P19-0006 MEADOW OAK TOWNHOMES
EXHIBIT A - LOCATION MAP

TENTATIVE MAP FOR MEADOW OAK TOWNHOMES - TM04-1388

**P19-0006 MEADOW OAK TOWNHOMES
EXHIBIT H - COMMENTS, PG&E**

**P19-0006 MEADOW OAK TOWNHOMES
EXHIBIT I - COMMENTS, EL DORADO IRRIGATION DISTRICT**

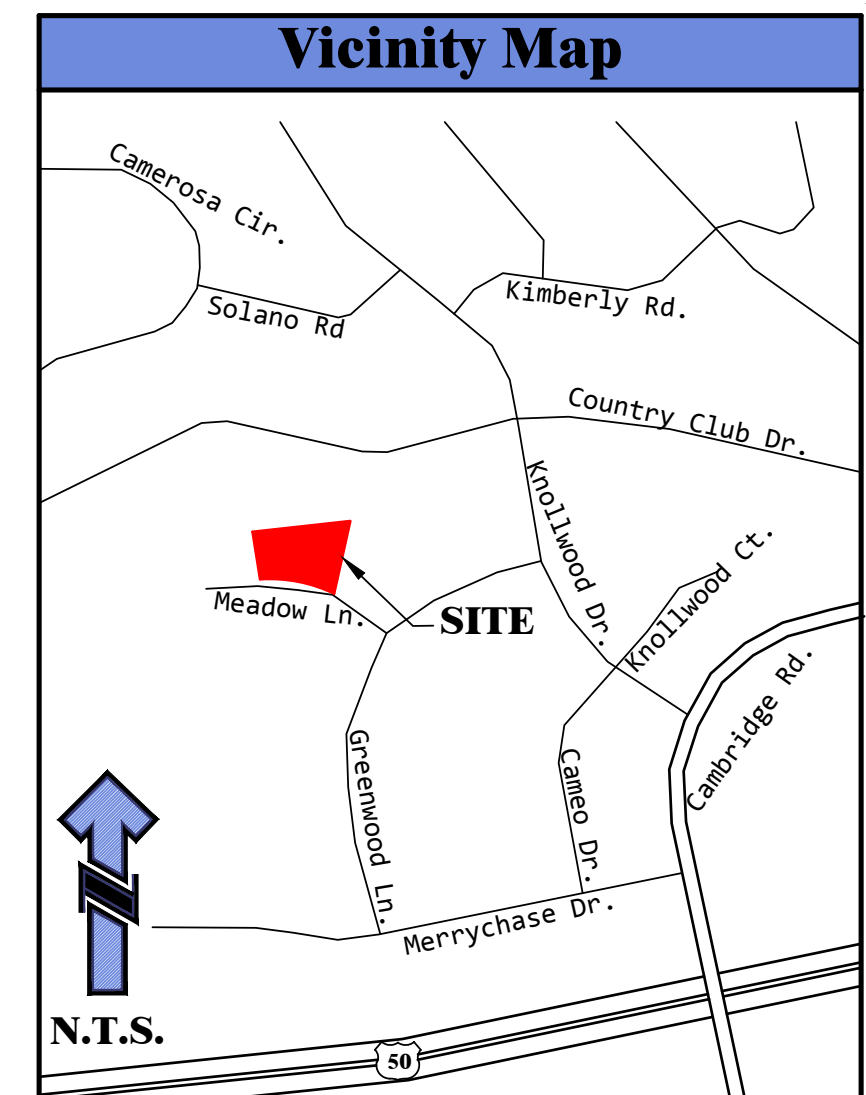
Per our records each townhouse has its own water meter and sewer service. I do not know the location of each meter relative to the proposed parcel lines, but assume some of meters will end up being on a parcel they do not serve. Those parcels will need to enter into "offsite service agreements" with EID.

Also, per our record there is a 5th meter onsite, which I assume is a landscape meter. The resulting parcel where that meter is located will be responsible for the account. They may want to establish an agreement between the parcels regarding maintenance/irrigation of the common areas?

A FIL will be required if the Fire Marshall requires any fire protection upgrades/new FH associated with this parcel split.

- 1) All survey monuments must be set prior to filing the Parcel Map.
- 2) Prior to filing the Parcel Map, a letter will be required from all agencies that have placed conditions on the map. The letter will state that **“all conditions placed on P19-0006 by (that agency) have been satisfied.”** The letter is to be sent to the County Surveyor and copied to the Consultant and the Applicant.

Landscaping And Existing Growth:
Install landscaping in the area between the driveway access and Meadow Lane.

Fencing:
If fences are the original fences from when the units were built, replace the fences.
